**ADDENDUM NO. 2**

March 18, 2016

**ADDITIONS AND REMODELING TO  
ROBERT ASP, ELLEN HOPKINS AND S.G. REINERTSEN ELEMENTARY SCHOOLS  
MOORHEAD AREA PUBLIC SCHOOL DISTRICT 152  
MOORHEAD, MINNESOTA**

DESCRIPTION: FIRE PROTECTION REVISIONS  
 SHEET NO: ADM1.0  
 1 OF 2

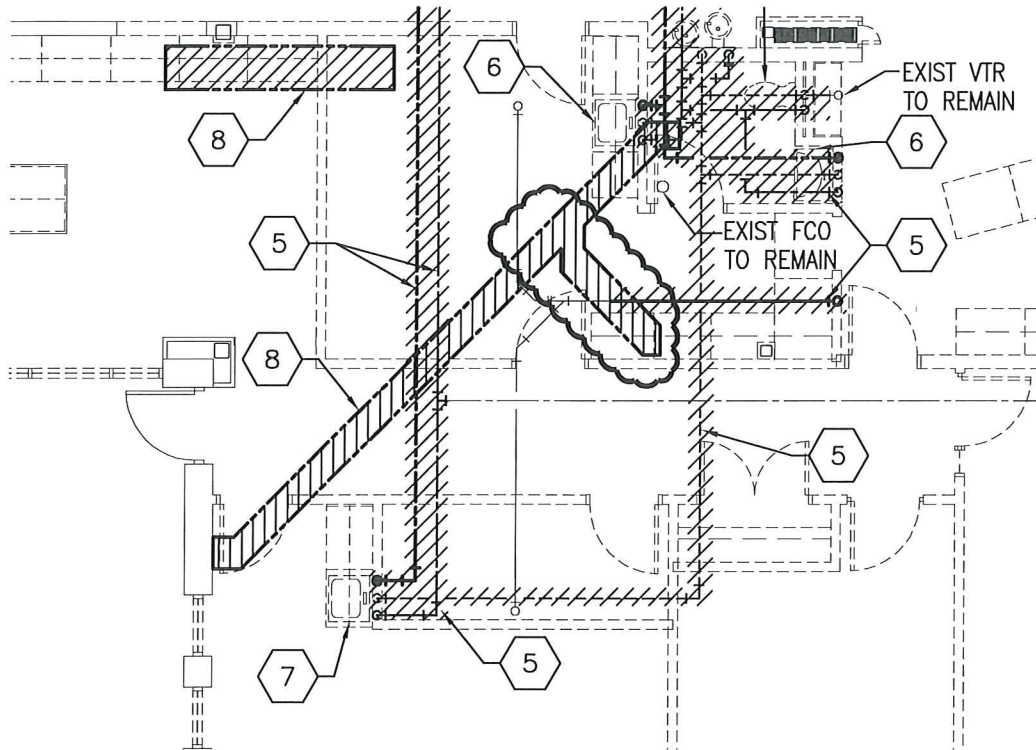
1. See attached sheet ADM1.0 for addition of areas where sprinkler heads may need to be relocated for the installation of new security doors.
2. An unbraided corrugated stainless steel flexible sprinkler connection will be allowed in lieu if the braided flexible sprinkler connection called for on detail 3.

1. See attached sheet ADM1.0 for addition of areas where sprinkler heads may need to be relocated for the installation of new security doors.

DESCRIPTION: SGR PLUMBING REVISIONS  
 SHEET NO: ADM1.1  
 2 OF 2

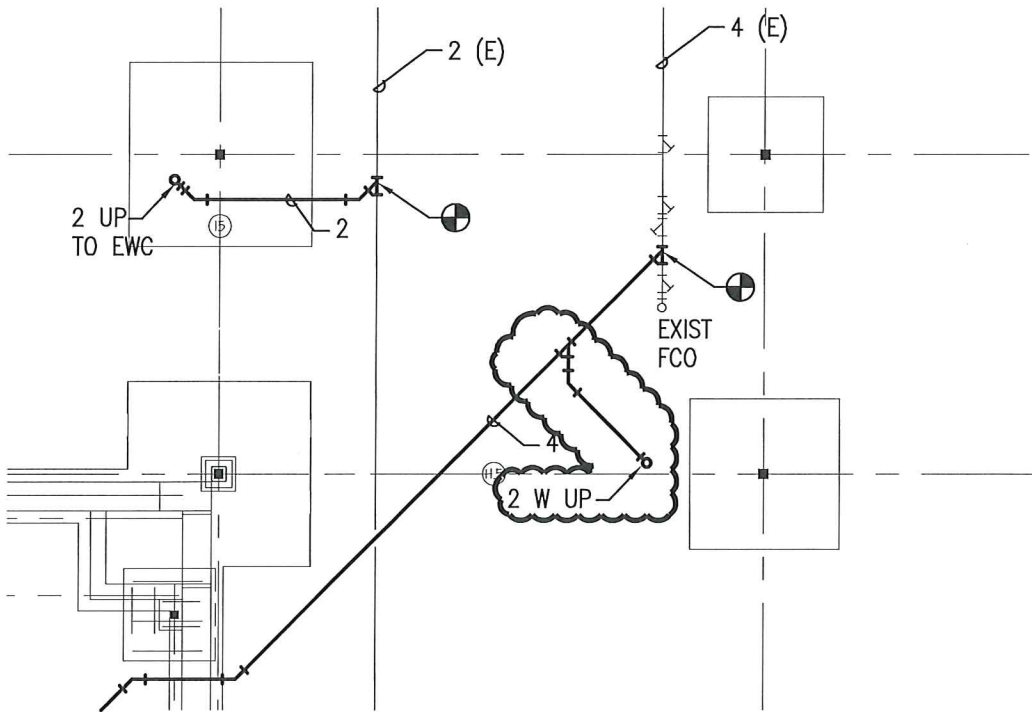
1. See attached sheet ADM1.1 for connection of existing penthouse floor drains to new sanitary sewer piping underslab. Div. 3A to saw cut existing concrete floor to accommodate installation of new piping.
